PERMIT

SEWAGE DISPOSAL SYSTEM

HOWARD COUNTY HEALTH DEPARTMENT

SUBDIVISION Glenwood Estates LOT J-3 ROAD 3470 Sharp Road

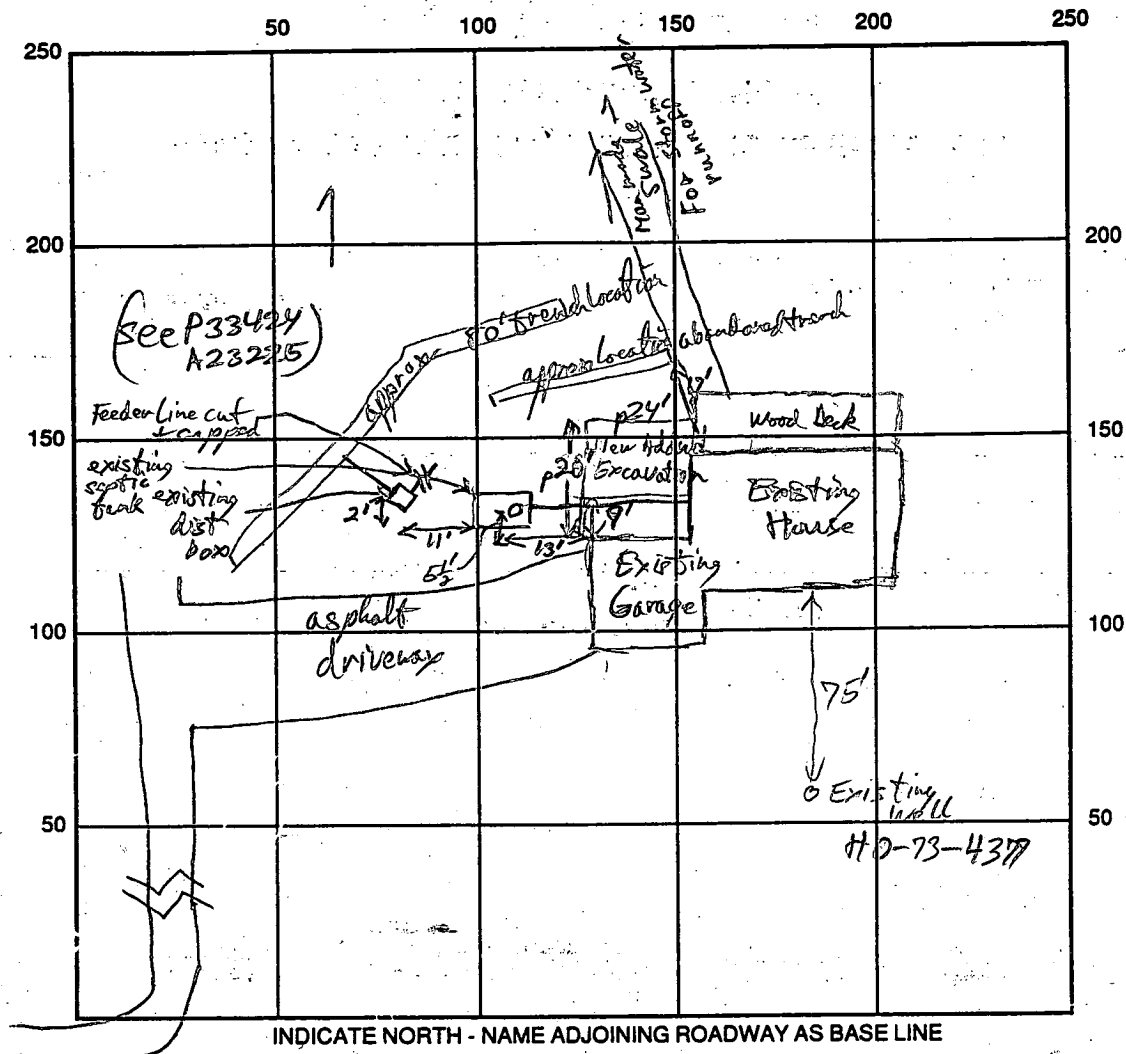
REPAIR - Authorize abandonment of one existing trench to accommodate planned addition
(Building Permit # Replacement of abandoned trench recommend, but not
required. House has limited occupancy.

REMARKS: Existing end septic tank and distribution box were uncovered; Feeder line to shorten trench was cut and capped at dist. box side (ie. 43' trench, closest to Addn. Basement wall has been abandoned). No replacement trench is being installed - No evidence of septic problem in exposed parts of system or on ground were observed. RP 9-12-91

GRADING STUDY
PARCEL U-3 (560)
GLENWOOD ESTATES
4TH DIST.
HO. CO. MD.

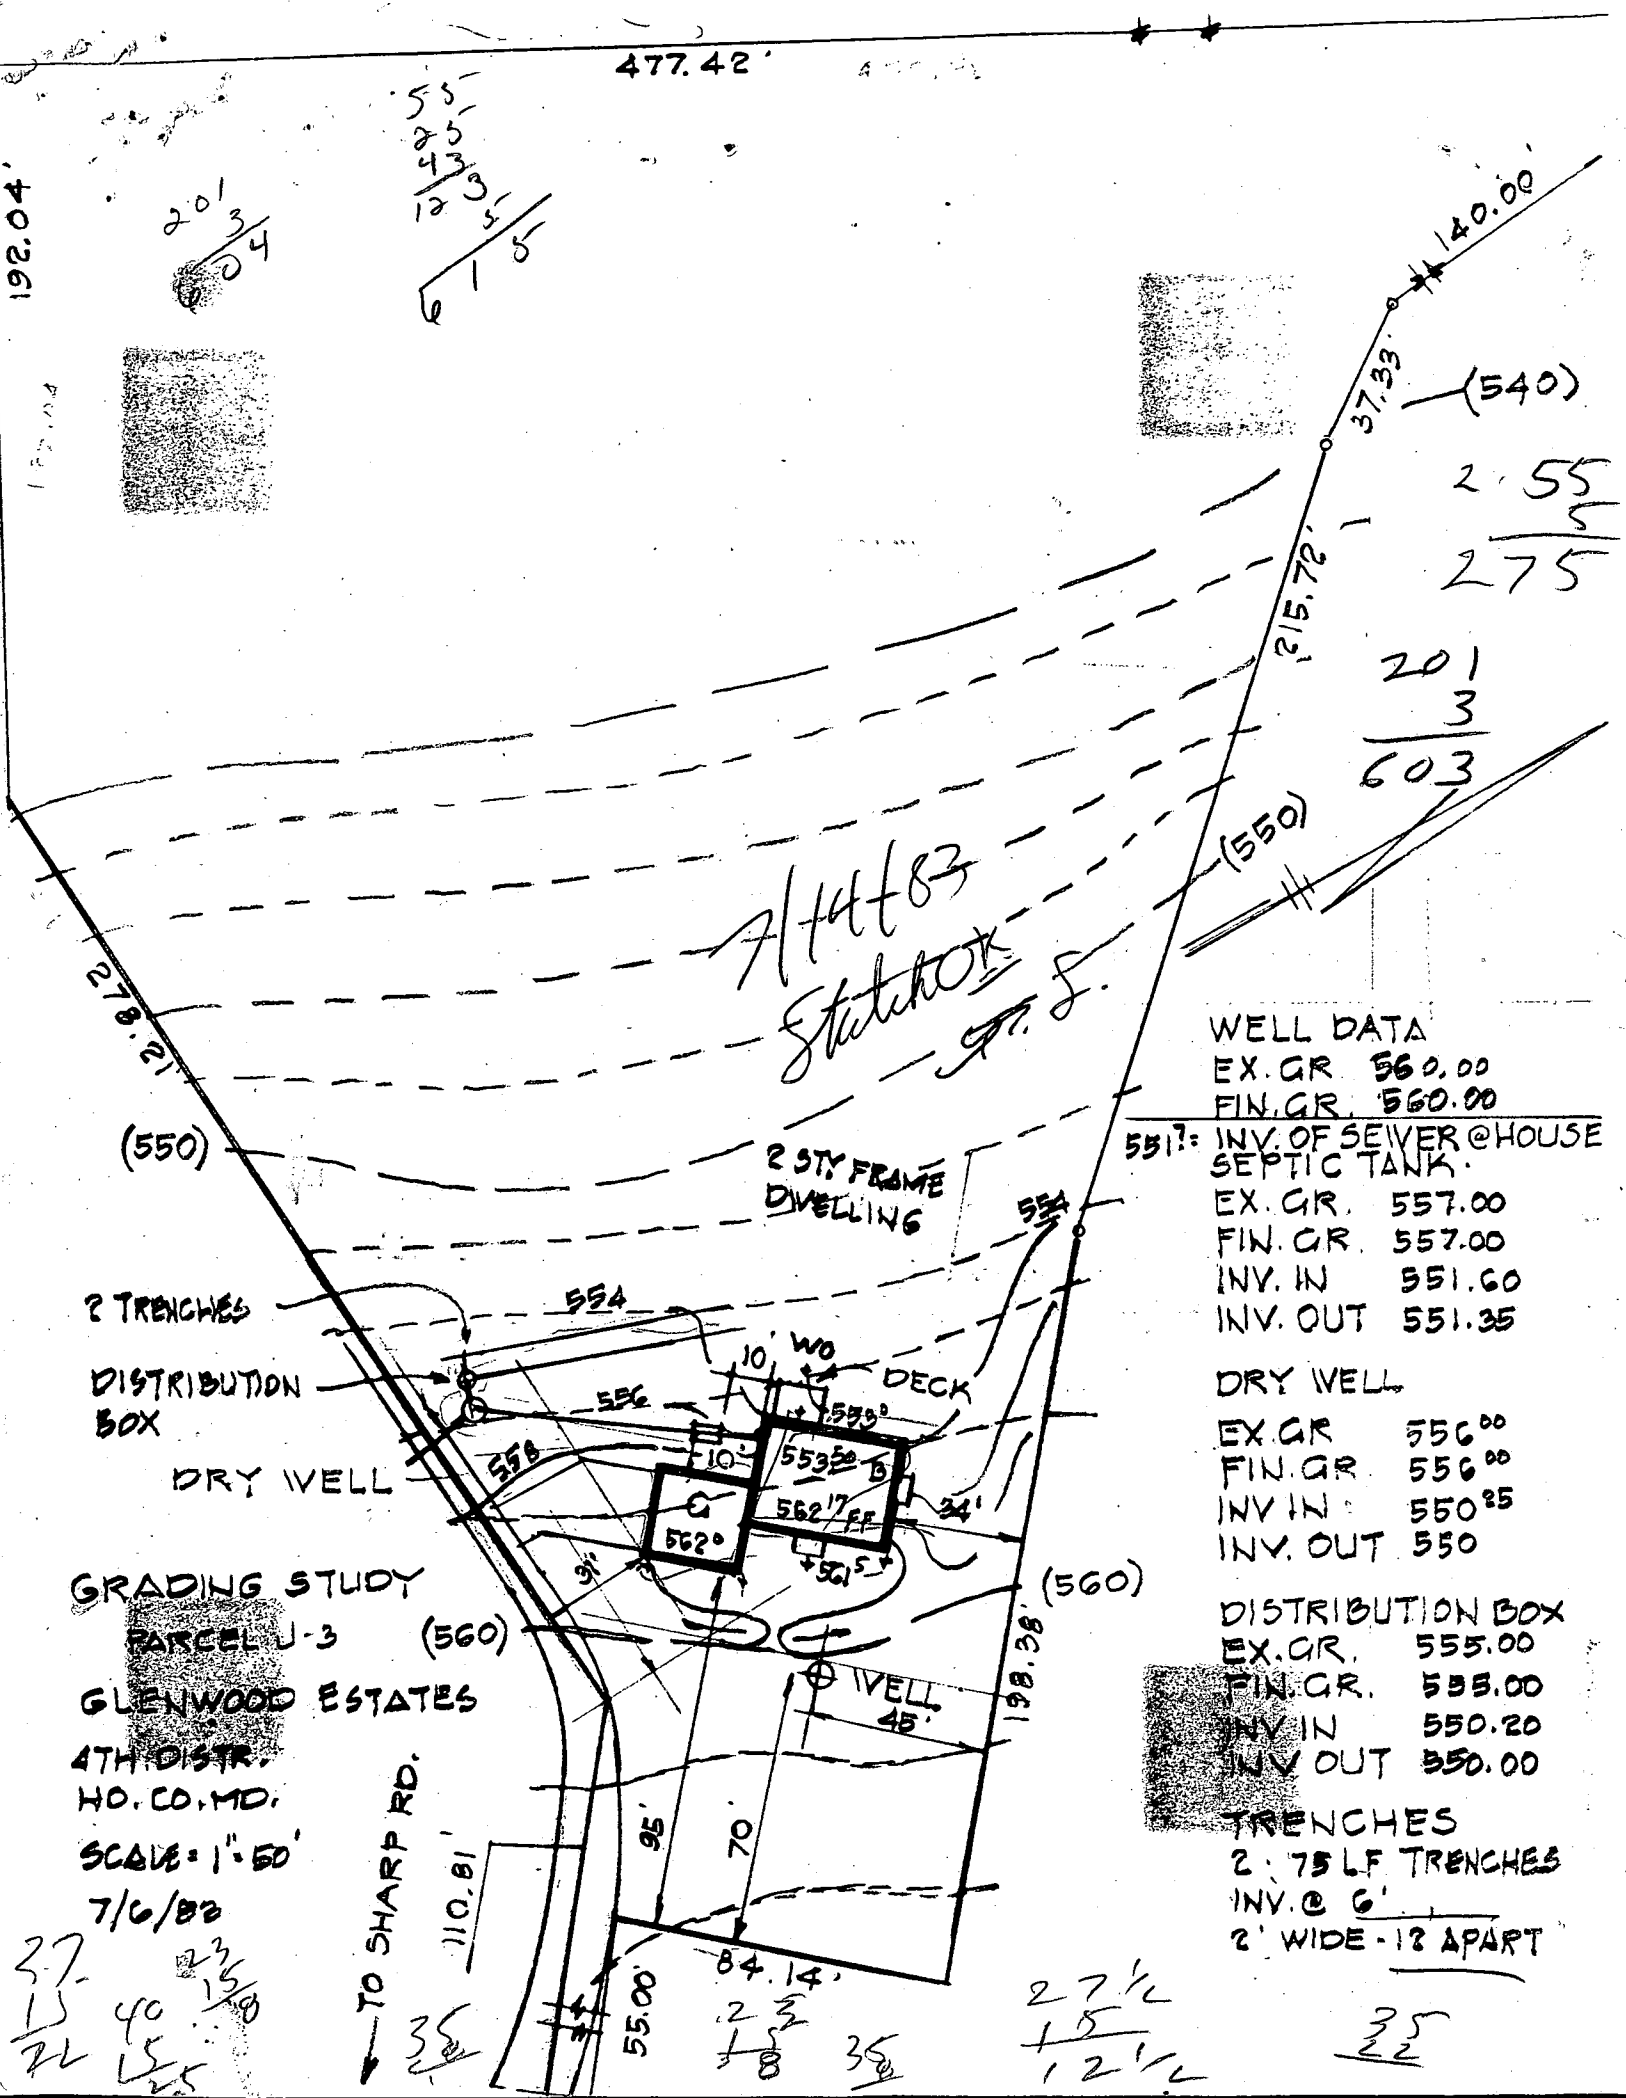
PROPOSES ADDITION WHICH WILL IMPACT
SEPTIC SYSTEM, ALL THOUGHTS ABOUT MODIFICATION OF PLANS
HAVE ASPECTS INCOMPATIBLE WITH INTENT OF ADDITION.

APPLICANT TO SUBMIT WRITING REQUEST RE: THIS
6/25/91 CWL
